**CONTINUED PUBLIC HEARING MEMORANDUM**

**PETITION #119-15**

**28 AUSTIN STREET**

Request for Special Permit/Site Plan Approval to redevelop a municipal parking lot with a mixed-use building and 127 public parking stalls

# PROPOSED RECONSTRUCTION OF WALNUT STREET NEWTONVILLE (NEWTON), MASSACHUSETTS

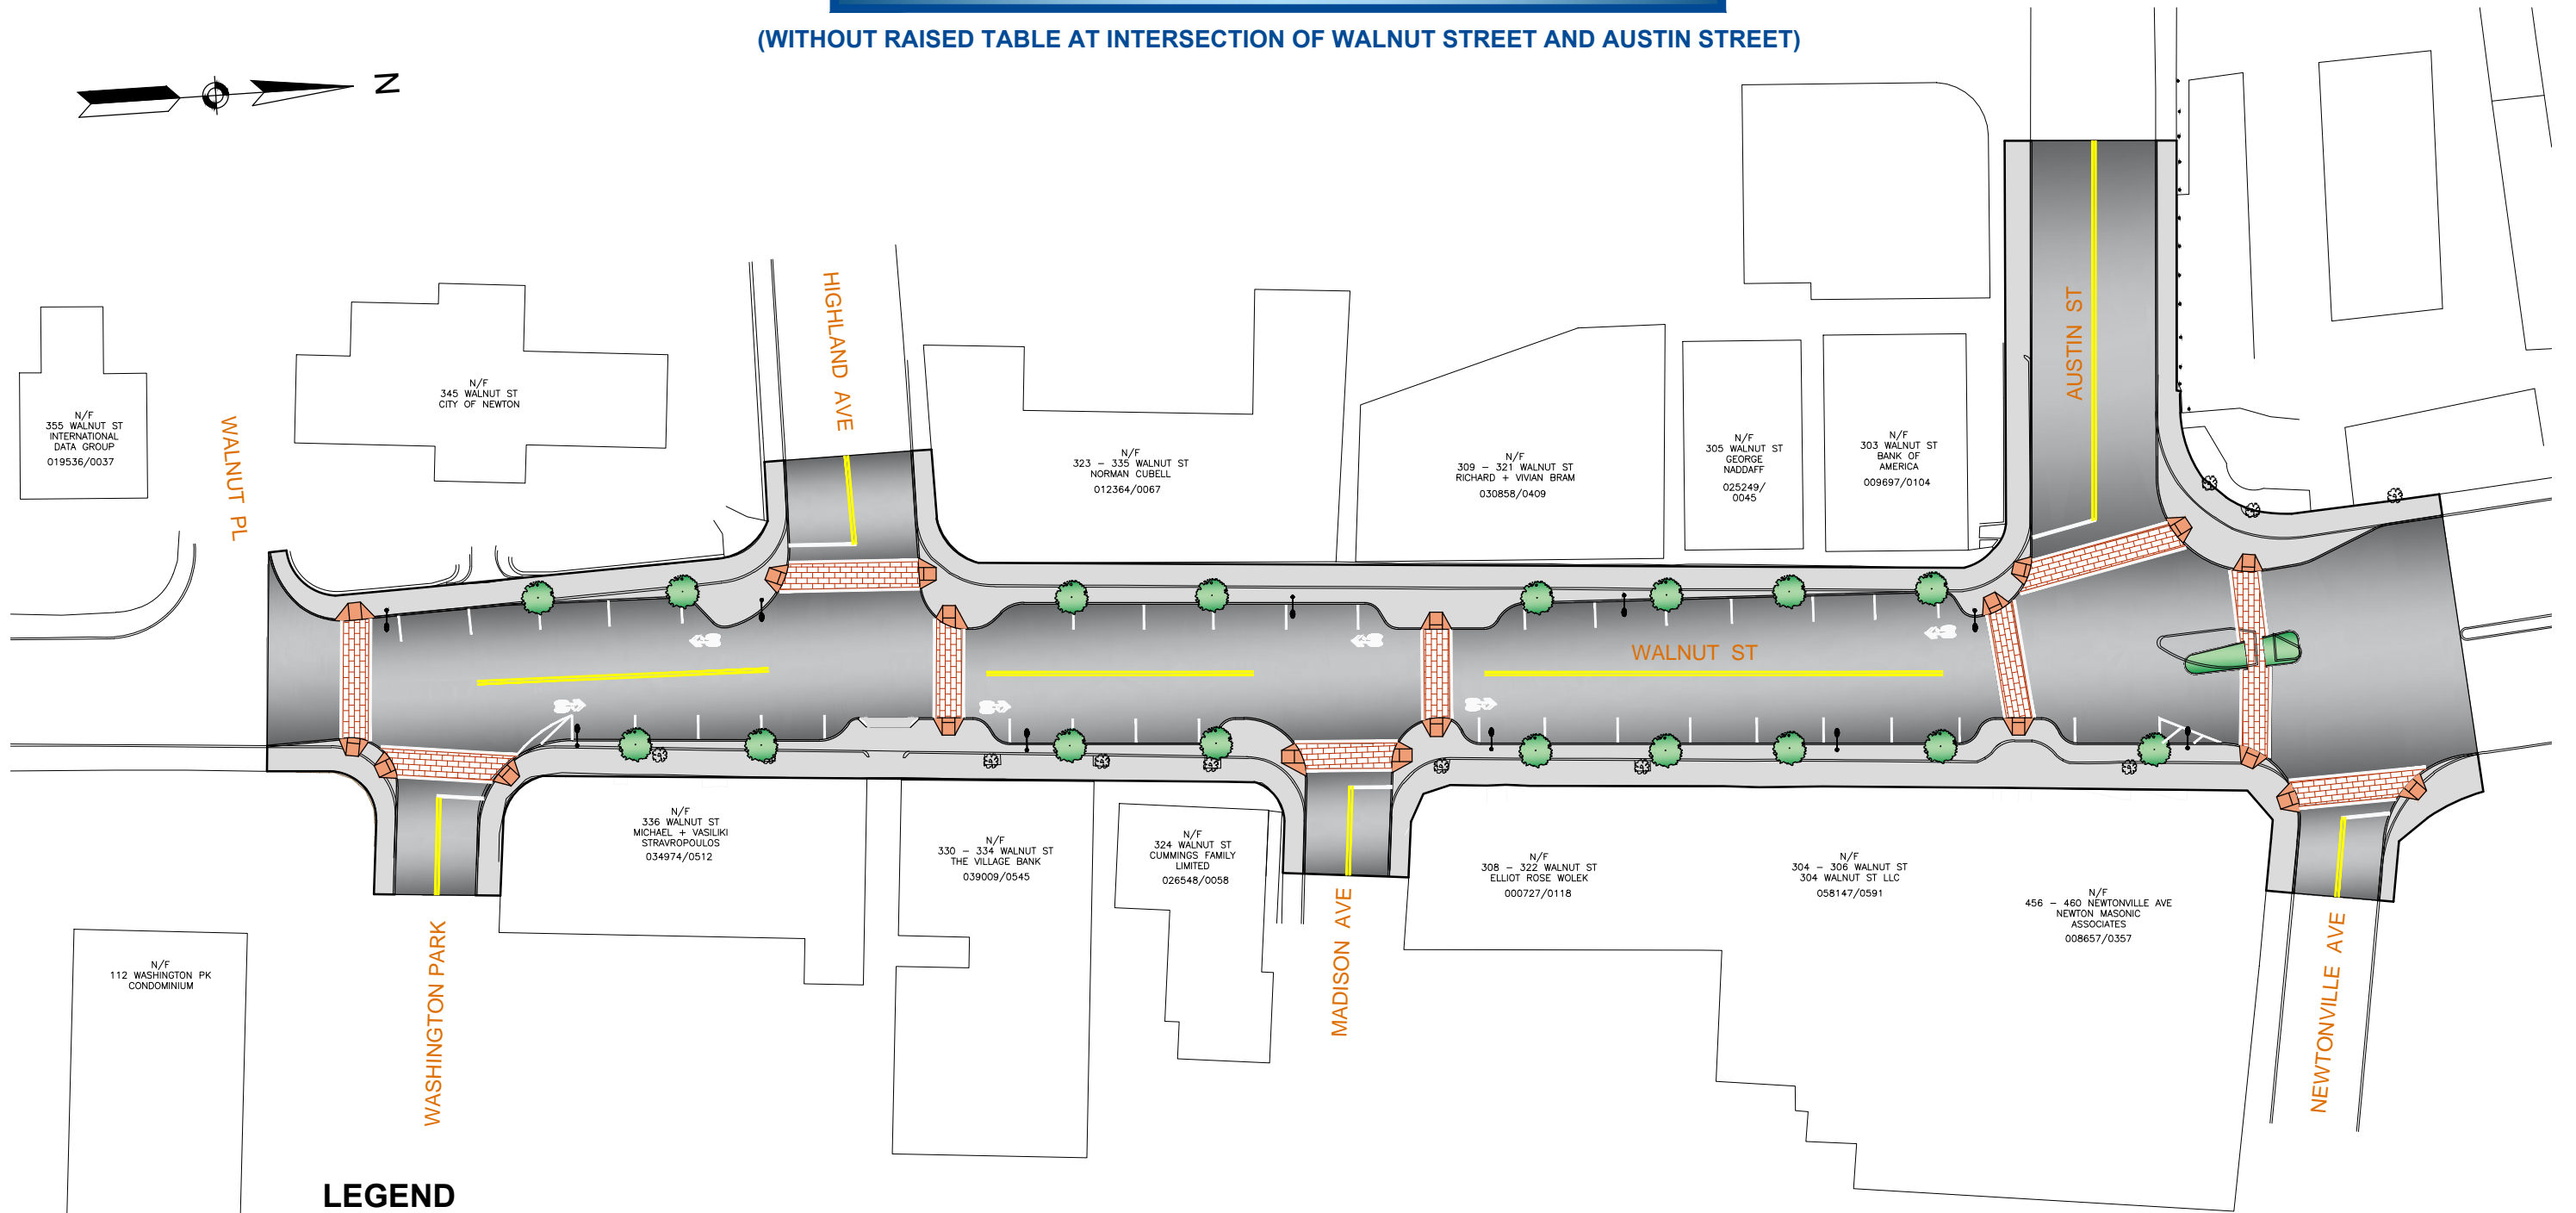
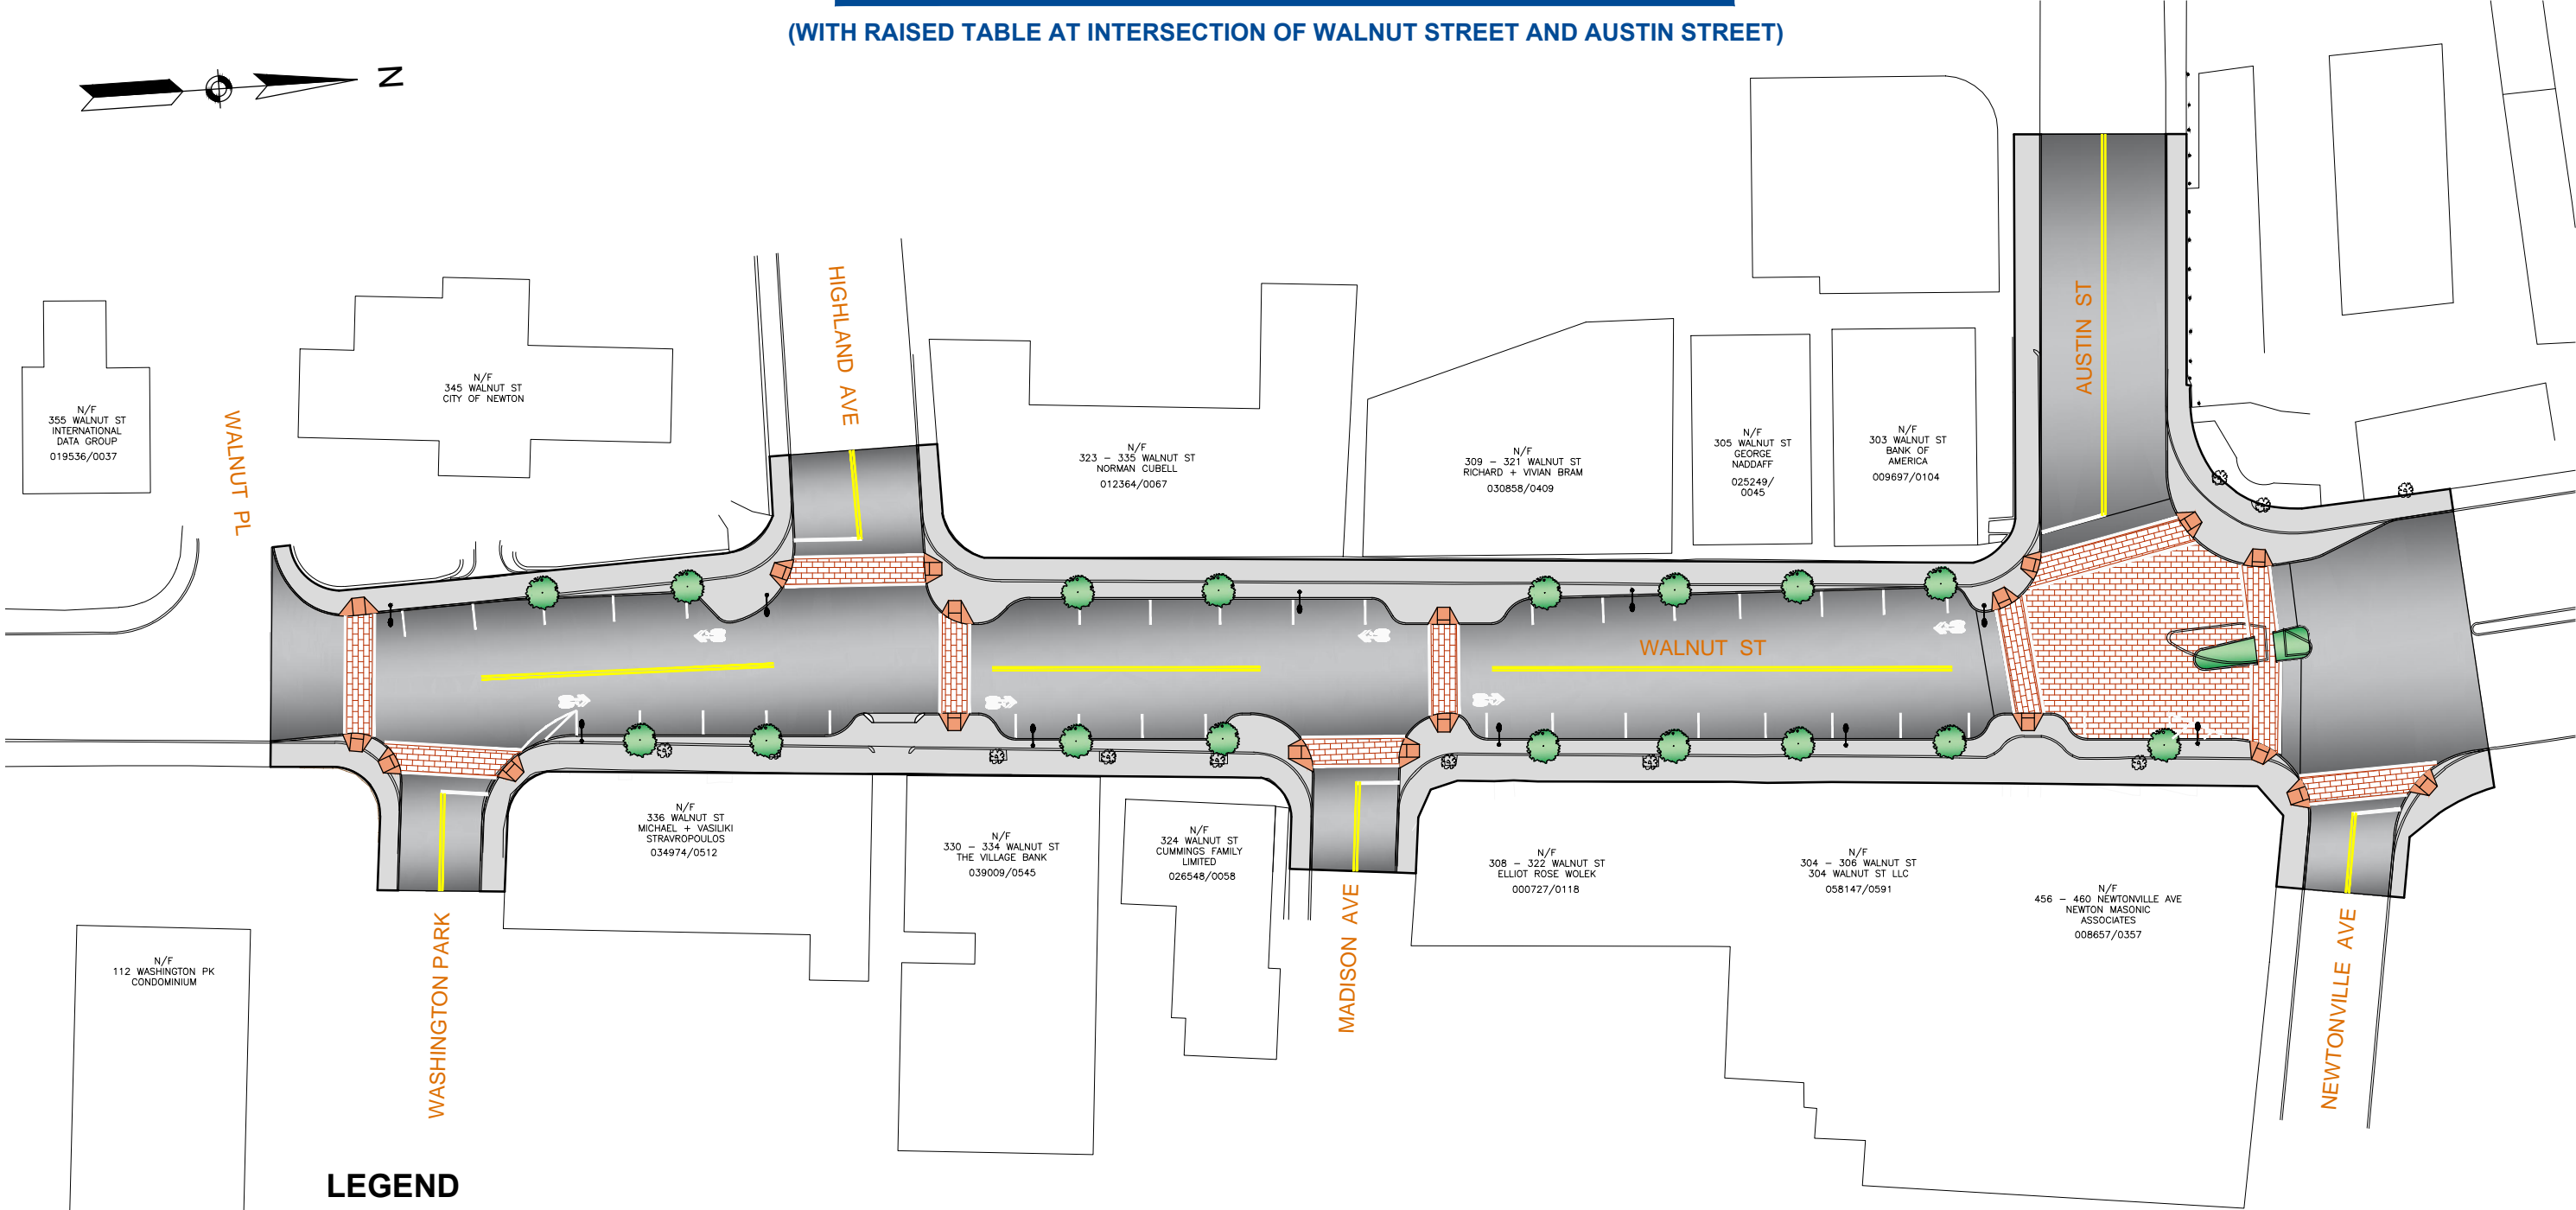
As an alternative to installing a traffic signal, geometric improvements at the intersection would serve better to channelize traffic, shorten pedestrian crossings, improve sight distance for vehicles exiting the Austin Street and Newtonville Avenue approaches, and enhance the overall aesthetics and context of the intersection. These improvements would be constructed in conjunction with the City’s reconstruction of Walnut Street through the village center, which seeks to eliminate the existing striped median along Walnut Street, reduce the roadway width, and widen sidewalks. These improvements may include the following:

- Wider sidewalks along Walnut Street and Austin Street
- Curb extensions at corners to shorten pedestrian crossings and prevent illegal parking
- Reconfiguration or removal of the existing median island on Walnut Street between Austin Street and Newtonville Avenue to better channelize traffic and facilitate eastbound and westbound “through” movements
- Reduction in the number of lanes on Walnut Street over the I-90 overpass
- Improved lighting in the village center
- Raised crosswalks and/or raised table intersections
- Add bicycle accommodations
- Add wayfinding signage

Two conceptual alternatives for the improvement of Walnut Street incorporating some of these features are attached. These concepts are shown both with and without a raised table at the Walnut Street at Austin Street intersection.
